Certified Action of the City of Raleigh Planning Commission

Case File / Name: SP-31-10 / WakeMed Medical Office Building

Nature of Case: Construction of a four-story, 110,000 square foot medical office building and a three-story, 43,200 square foot medical office building on a 7.83 acre site zoned Shopping Center District.

SP-31-10 – Site Plan

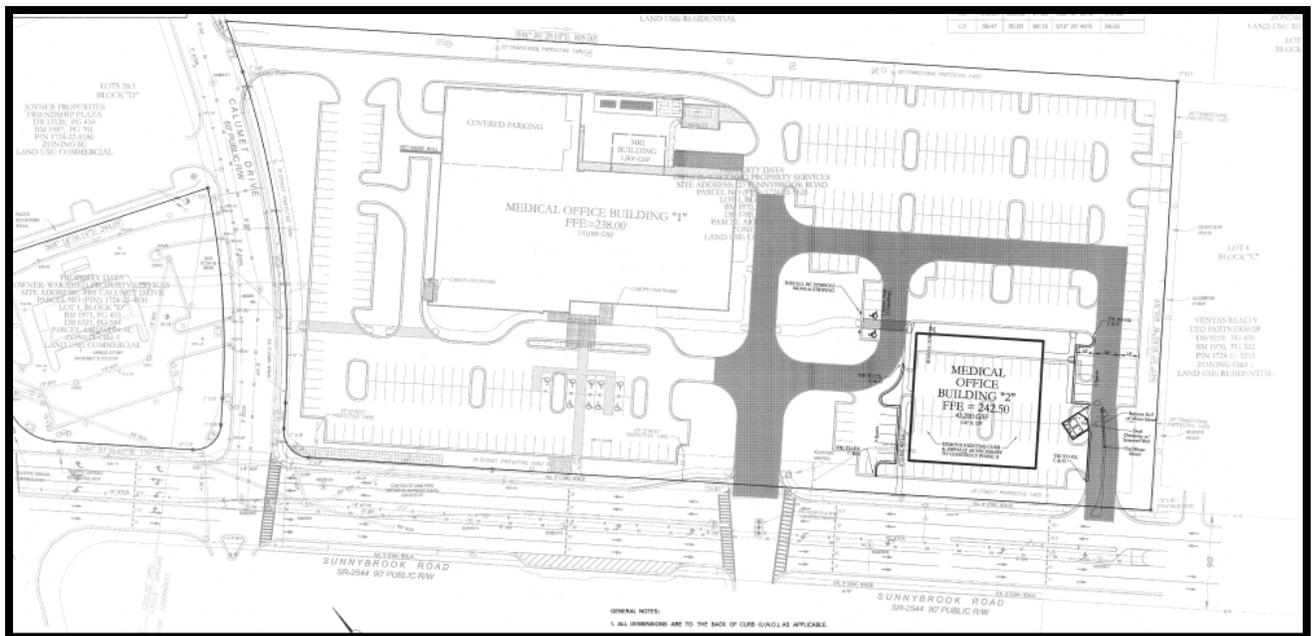
Key Issues: The Public Works Department is requesting two transit easements on this site: one on Calumet Drive and one on Sunnybrook Road. The applicant agrees to only dedicate one of the two easements (on Sunnybrook Road).

TRANSIT: The following transit-oriented features of this site are incorporated into the proposed plan: 15'x20' transit easement on Sunnybrook Road. City staff has requested an additional transit easement on Calumet Drive, but the applicant is not willing to dedicate the transit easement. The transit easement is being required for the following reasons:

Of the nine applicable policies staff does not believe the following four are met with this proposal and that Planning Commission should evaluate these issues:

- Policy LU 2.2 - Compact Development
- Policy LU 5.1 - Reinforcing the Urban Pattern
- Policy LU 7.6 - Pedestrian Friendly Development
- Policy T 4.8 - Bus Waiting Areas

- (1) That a 15x40 foot transit easement located on Sunnybrook Road be approved by the Transit Planner in the Public Works Transportation Department, be recorded prior to building permit issuance, be shown on all maps for recording, and that a transit easement deed approved by the City Attorney is recorded with the local County Register of Deeds. That the recorded copy of this transit easement deed be provided to the Planning Department within 14 days of authorization for recording and prior to building permit issuance. If a recorded copy of this easement is not provided to the Planning Department within the 14 day period, further plat recording and building permit authorization may be withheld;

- (2) That as agreed upon by the applicant, a bus shelter be constructed on Sunnybrook Road with the Planning Director overseeing the process and design approved by the Transit Planner in the Public Works Department;
